September 30, 2021

**Subject: Notification of Crossing Improvement Adjustment**

**Copans Road Improvements:**

**NE 33rd St Improvements:**

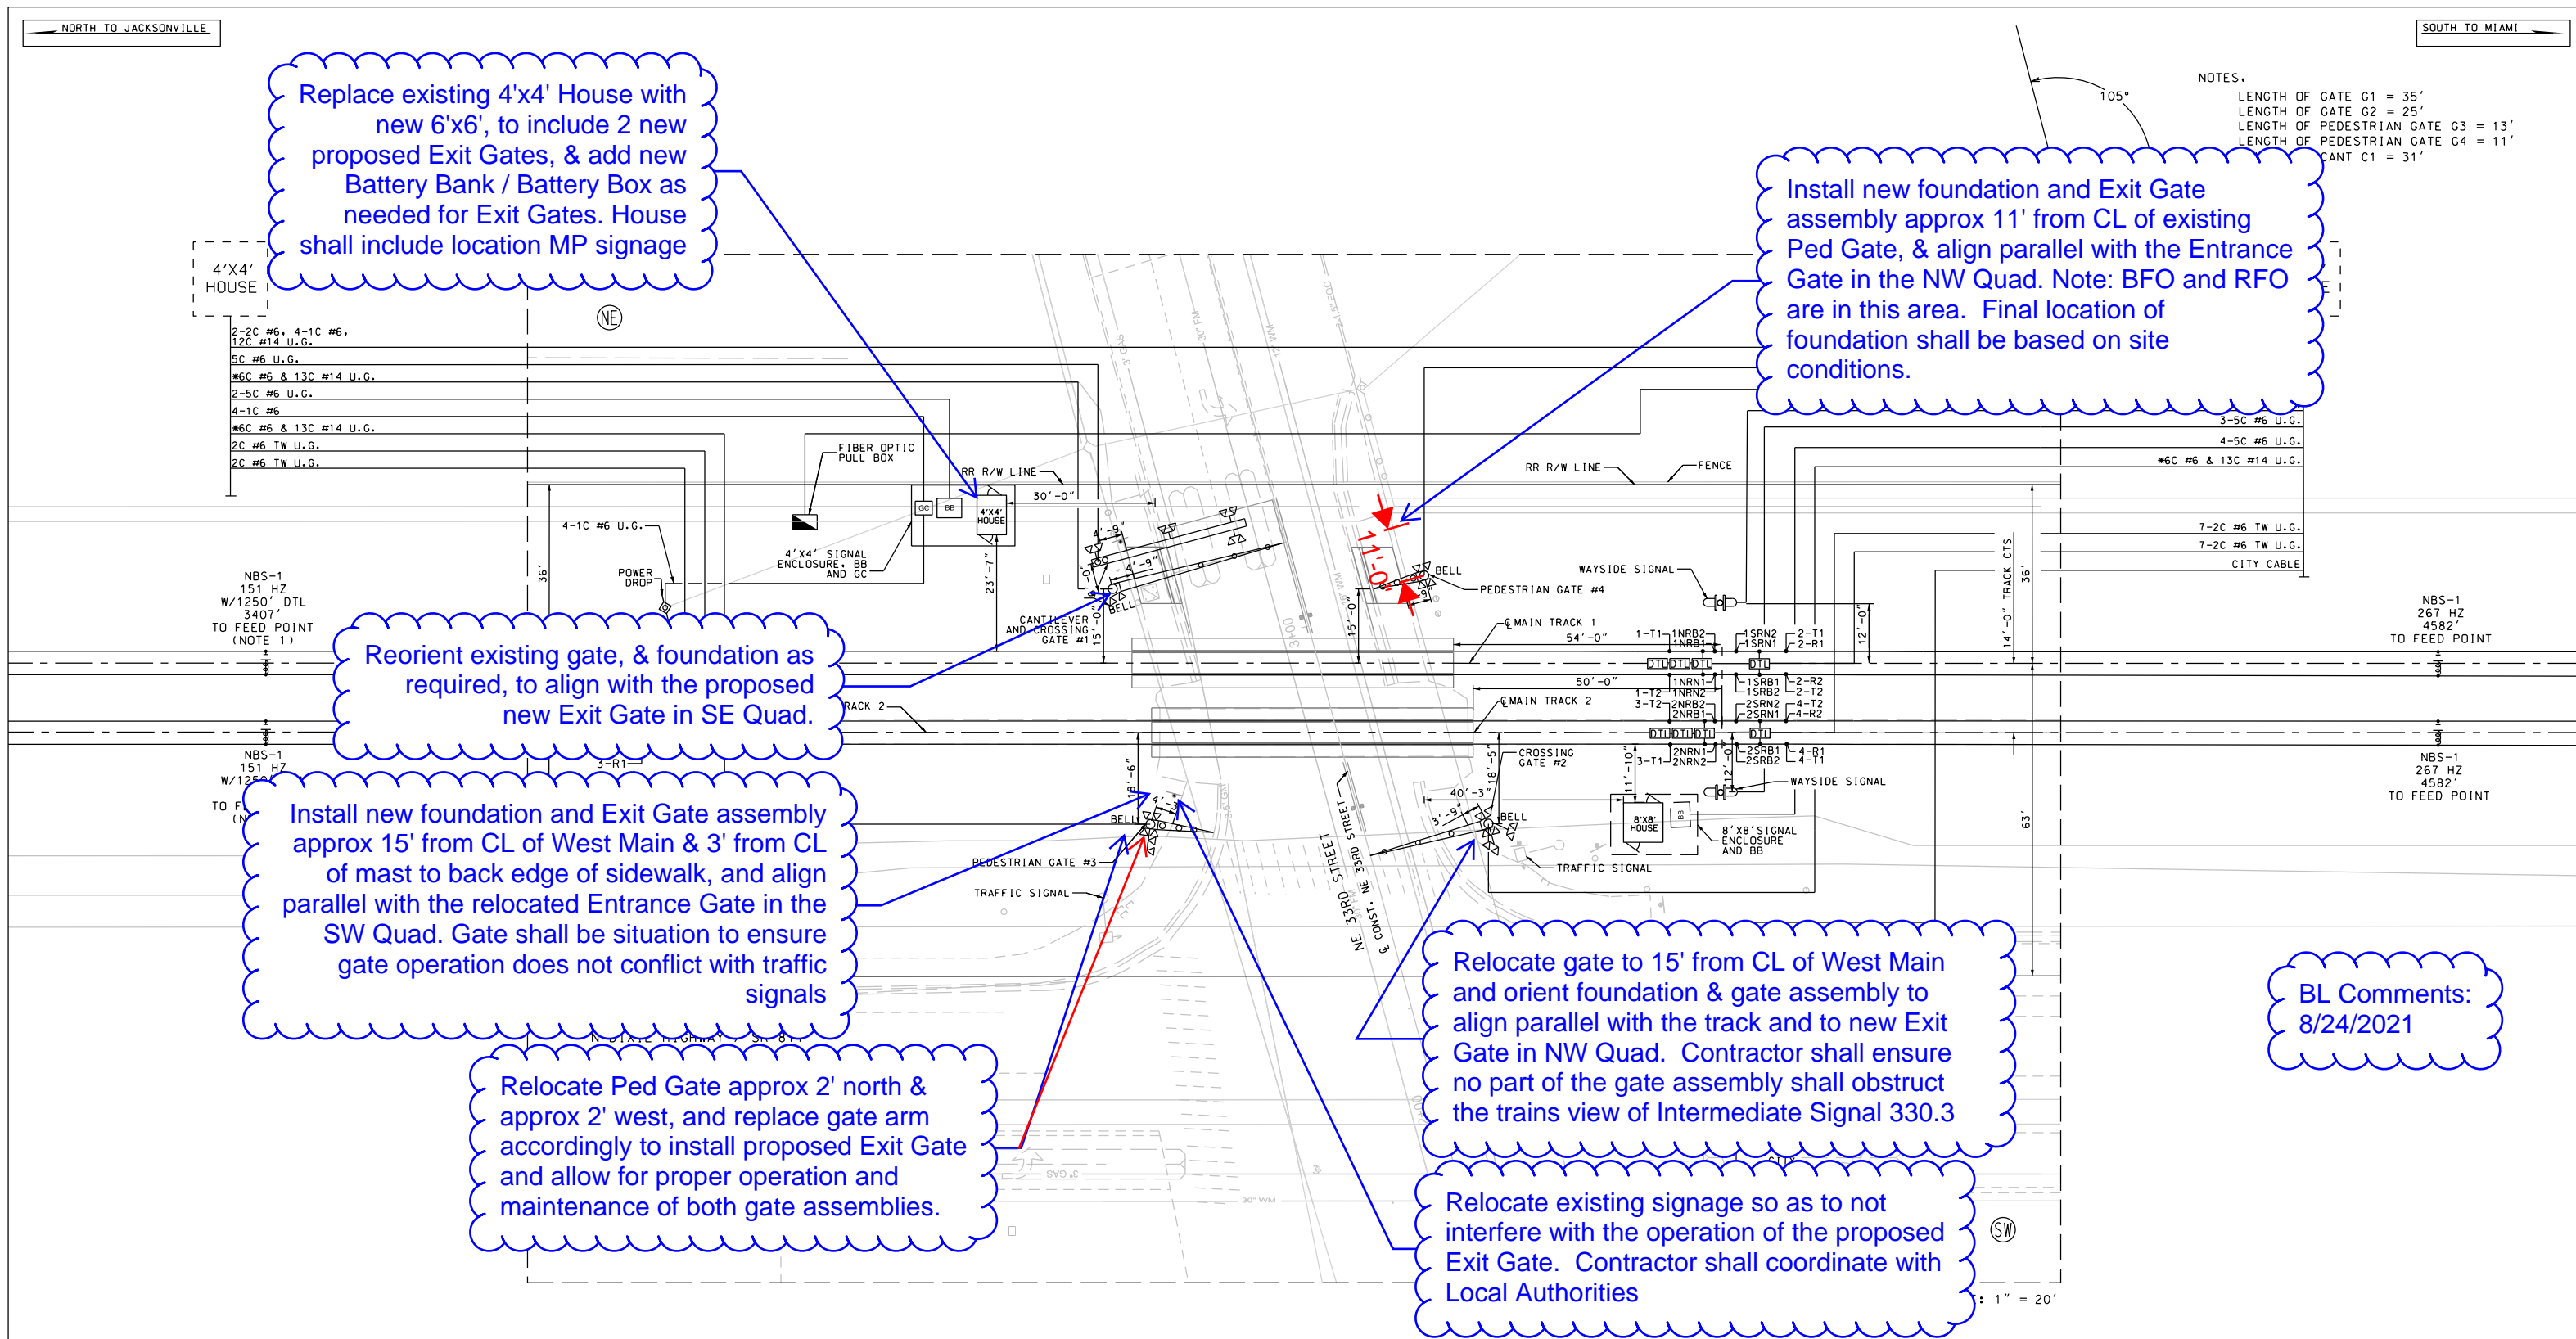
The original improvements planned for Copans Road included edge markings & striping through the crossing and an exit gate in the NW quadrant of the crossing. As the site investigation and design work progressed, Brightline determined that the existing roadway characteristics along the west side of the railroad tracks at Copans Road and Dixie Highway limit the options for installing an exit gate.

As presently configured, the westbound lanes in the NW quadrant measure out to 50'5" from sidewalk curb to median island curb. With the additional width of the sidewalk and required setbacks, the total distance of that quadrant is more than 60'. There were two options considered for installing an exit gate at this location (please also refer to the attached sketch for Copans Road):

1. Utilizing one exit gate with a longer arm and installing the base in the NW quadrant behind the sidewalk edge. This was determined not feasible because the distance exceeds the manufacturer's maximum exit gate arm length of 32'.
2. Utilizing two exit gates with shorter arms and installing one base in the NW quadrant behind the sidewalk edge and one in the median island. This was determined not feasible because the median is too narrow (10'6") to accommodate a second gate base and has existing obstructions. An entrance gate base and a stanchion for the flasher bridge currently occupy the median.

During the design process, the Brightline team also evaluated two other options in order to be able to install an exit gate at Copans Road. One option was widening the median, which would require eliminating one of the westbound travel lanes. The other option evaluated was lengthening the median island westward, which would require eliminating the northbound right turn lane on Dixie Highway. Both options we have deemed impractical/undesirable because of the vehicular capacity along these

roadways and at this intersection. Although we have determined that an exit gate is not feasible at Copans Road, the planned civil improvements (edge markings & striping) will remain as part of the improvements at this crossing.
